October 14, 2019

Project No. 12107.003

Subject: Geotechnical Response to The Bodhi Group Review Comments – Alta Oceanside Mixed Use Development, Oceanside, California.

GEOTECHNICAL MAP
North Coast Apartments
Oceanside, California

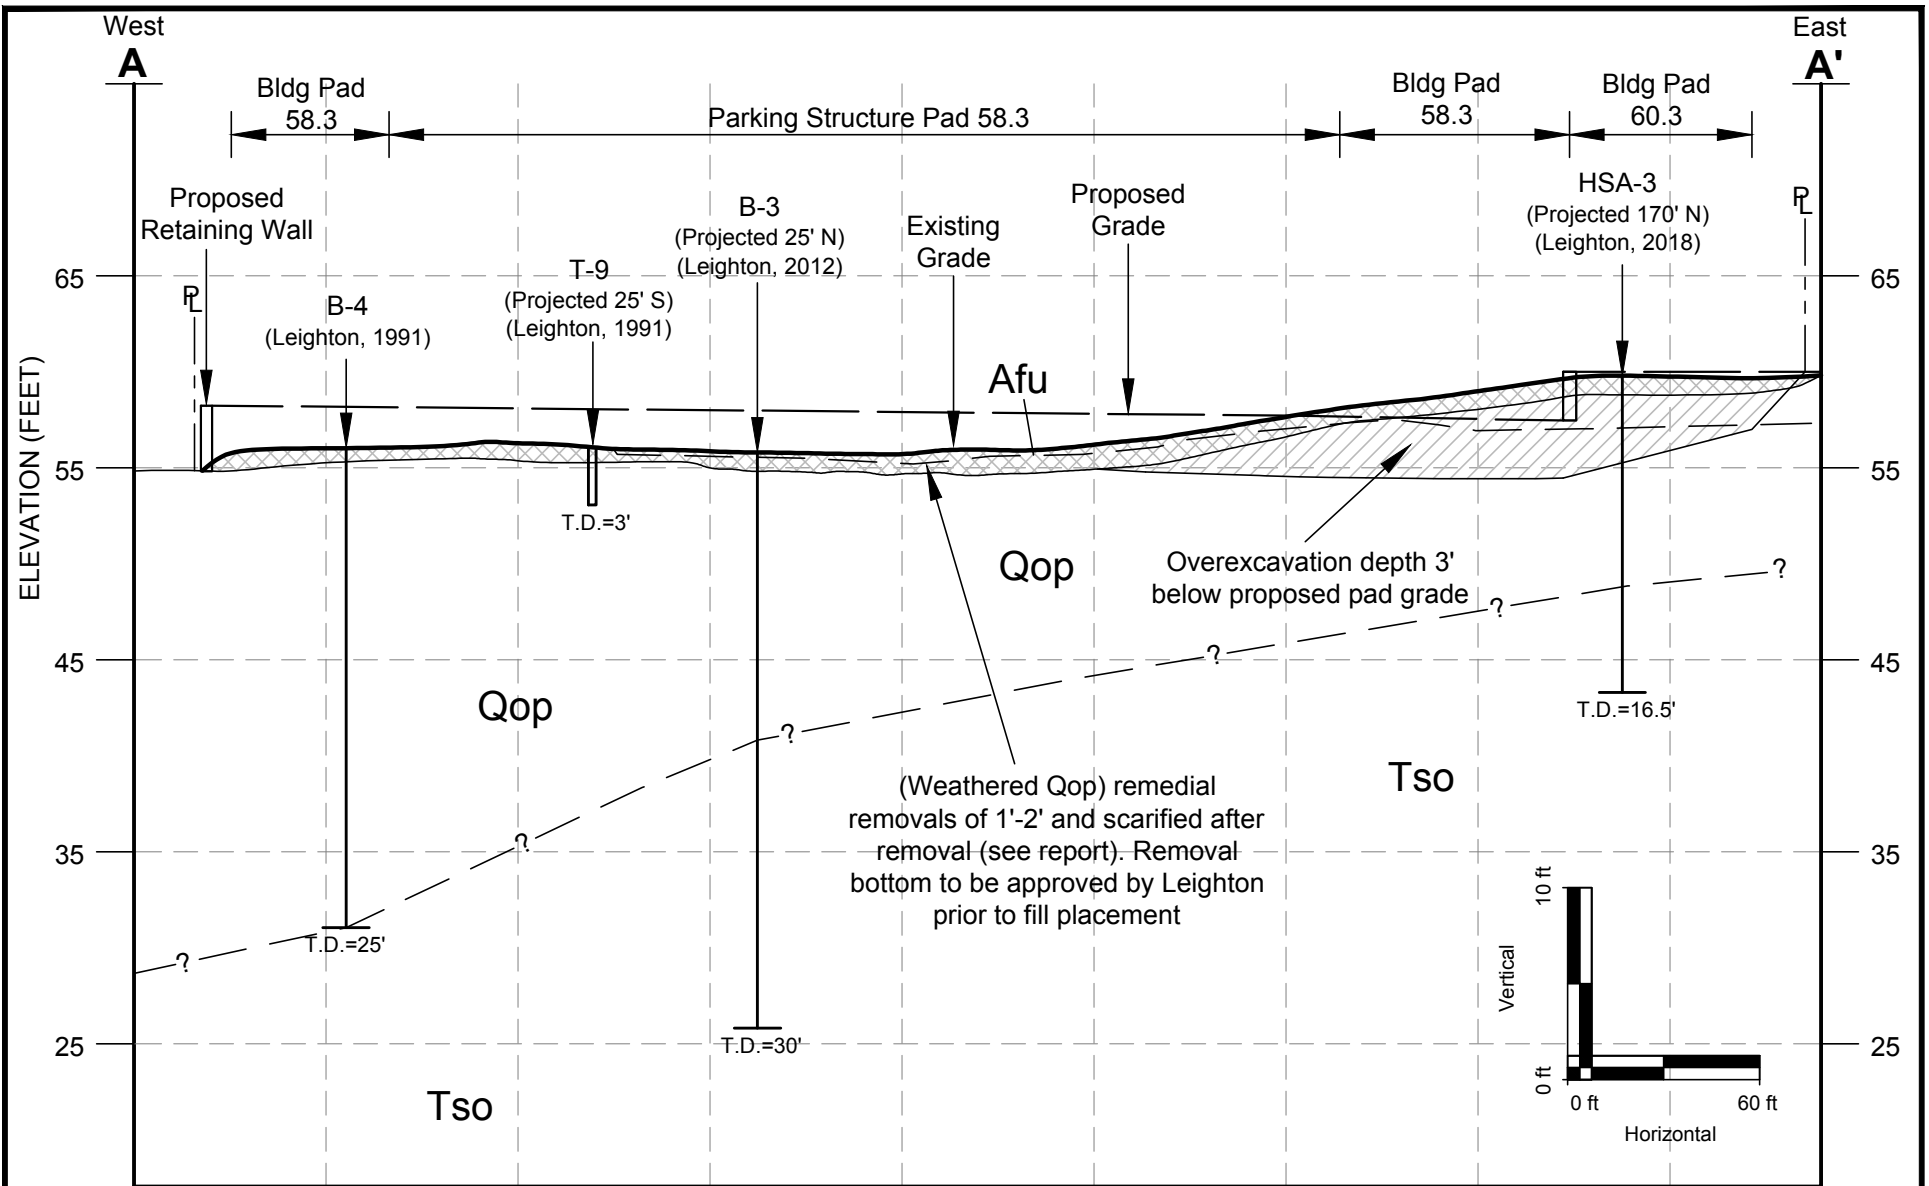
Information in the report indicates that San Onofre Breccia was encountered in borings B-3 (1991) and B-3 (2015), while San Mateo Formation was encountered in boring HAS-3 (Leighton 2018). These formations are described as being difficult to excavate. The impact that these formations might have on the development has not been discussed. It is recommended to clarify the underlying formation, and their depth across the Site. It will be useful to include one or more geologic cross-sections showing the anticipate subsurface conditions across the Site. The cross-sections should include data from the soil borings and test pits. It will be useful to show the relationship between the proposed construction and the slope discussed above.

Based on additional review of the available data, boring logs, and review of the Geologic Map of the Oceanside Quadrangle (Kennedy and Tan 2007), the underlying formation below the Old Paralic Deposits within the Site boundaries is the San Onofre Breccia and Leighton has updated the attached figures to include the San Onofre Breccia. Additionally, the attached Geologic Cross-Section A-A' Figure 2, shows the approximate

GEOLOGIC CROSS-SECTION B-B'

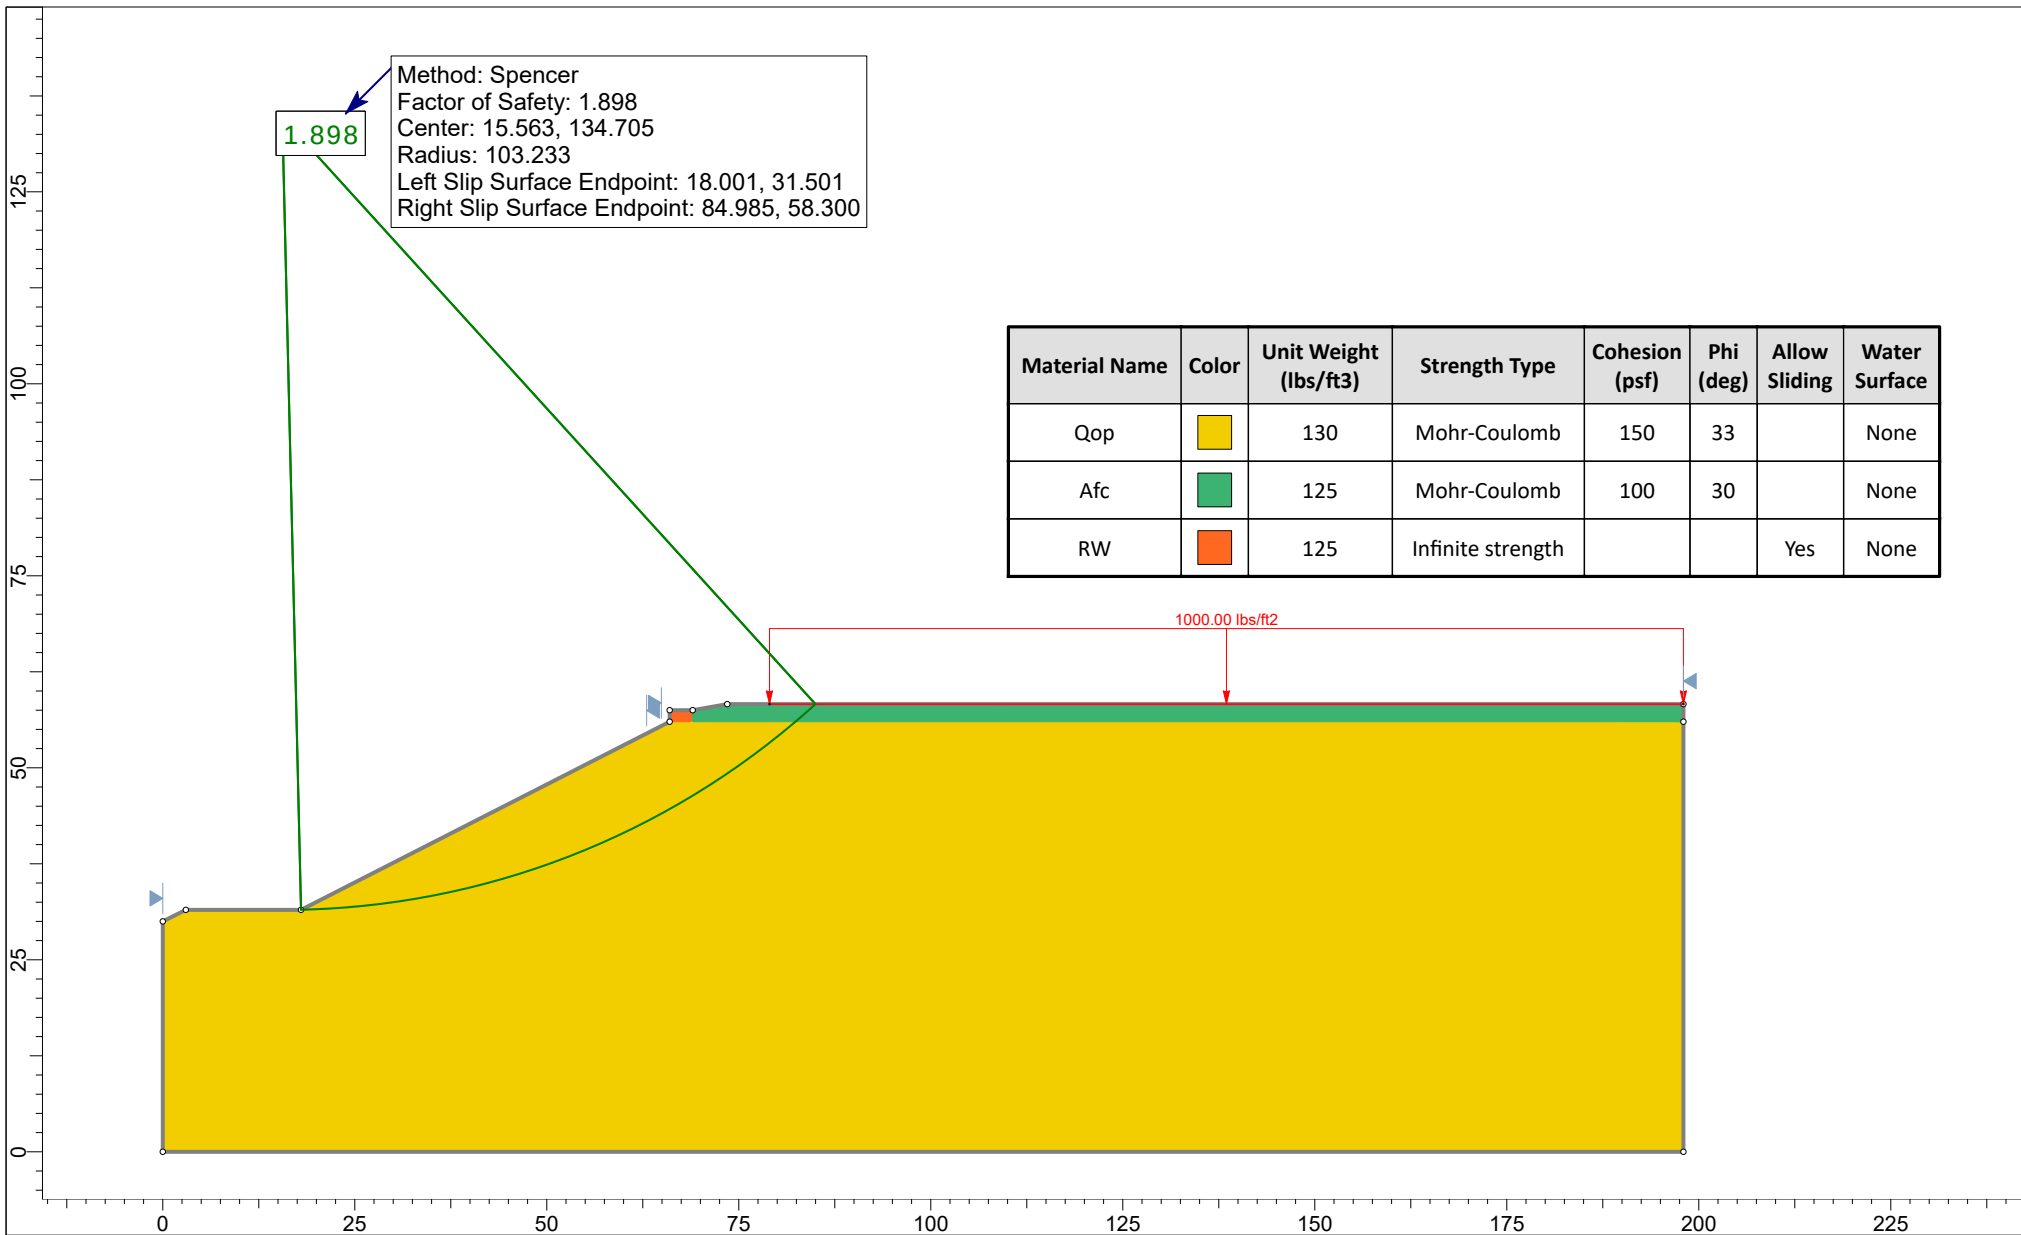
There is no discussion of the slope on the northern and northwest corner of the Site. The final report should include the slope characteristics and condition, the slope's surficial and gross stability, and the potential for the slope to affect Project construction.

As requested, Leighton has evaluated and analyzed for gross stability and surficial stability using the computer program Slide 6.0 (RocScience, 2018). Geologic Cross-section B-B' was utilized for our analysis which is included herein as Figure 3. Location of geologic cross-section is indicated on that attached Geotechnical Map (Figure 1). The parameters utilized in our slope stability analysis are presented on Table 1 and were based on our geotechnical investigations, our experience with similar soil types, and our professional judgment. A discussion of the results of the slope stability analyses is presented below.
